TO:	Horsham District Council – Planning Dept
LOCATION:	Land West of Bines Road Bines Road Partridge Green
DESCRIPTION:	Development of 101 dwellings (including 45% affordable), creation of new access, public open space, creation of a cycle path, allotments, and associated landscaping.
REFERENCE:	DC/25/1922
RECOMMENDATION:	Holding objection / Modification

NAME:	Andy Bush Arboricultural Officer
DEPARTMENT:	Strategic Planning (Specialist Team)
DATE:	02/01/26

Veteran Tree Buffer Encroachment

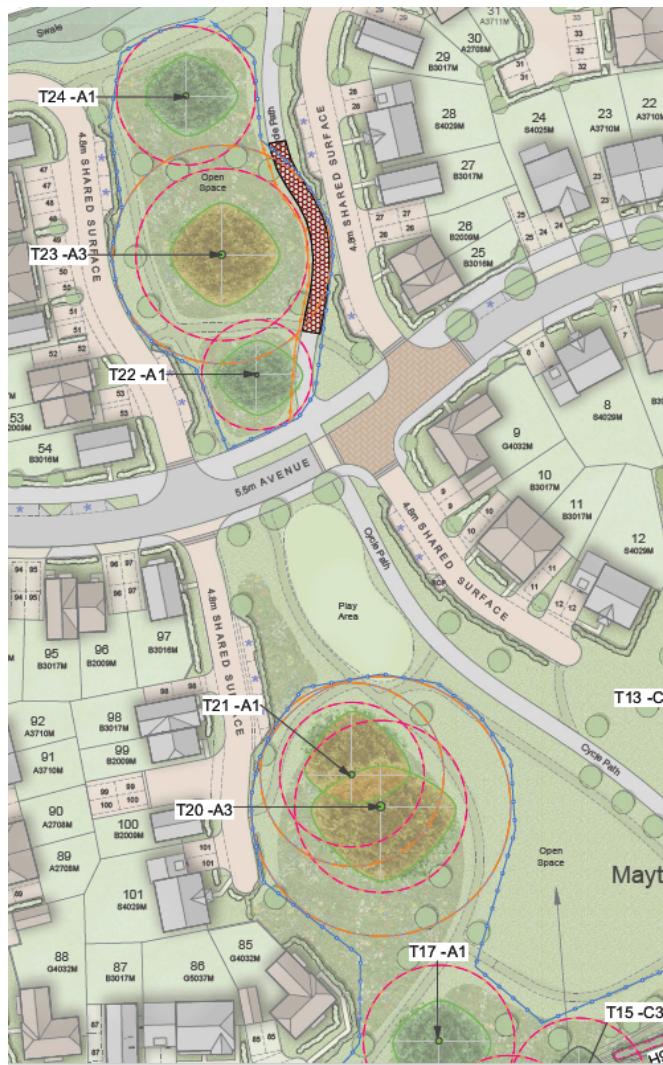
Notwithstanding the above, a proposed cycle path is shown to pass within the veteran tree buffer zone of T23, although it remains outside the calculated Root Protection Area (RPA) defined under BS5837:2012.

The AIA seeks to justify this encroachment on the basis of historic agricultural use, suggesting that repeated ploughing may have reduced rooting within this area. However, tree roots are typically concentrated within the upper soil profile, commonly within the top

1 metre, and ploughing depths rarely exceed 20–30 cm. In my opinion, it is therefore likely that rooting remains present throughout the veteran tree buffer zone, despite the historical land use. I note that the Cycle path is proposed to be built using a above ground construction technique which is generally considered to be acceptable when building within the key rooting area of a retained tree or trees.

Notwithstanding, current guidance is clear that veteran tree buffers should comprise semi-natural habitat and should not incorporate features that encourage regular access or trampling. The introduction of a cycle path, and pedestrian footways, within the buffer is therefore likely to result in increased disturbance and soil compaction, and other harmful tree related impacts over time.

It is also noted that both the Tree Retention, Removal and Protection Plan (dated 01/10/2024) and the Landscape Strategy Plan No. CSA/5573/105 appear to show the introduction of new pedestrian footways within veteran tree buffer zones (Please see below). These footways are not referenced within the supporting arboricultural documents and create uncertainty as to the full extent of development proposed within the buffers; please seek clarification on this point.

The introduction of development and post-development activity within veteran tree buffer zones would be inappropriate. To ensure the long-term protection of T23 and the other

veteran trees on site, it is still recommended that the cycle path and any additional pedestrian footways are rerouted entirely outside all veteran tree buffer zones.
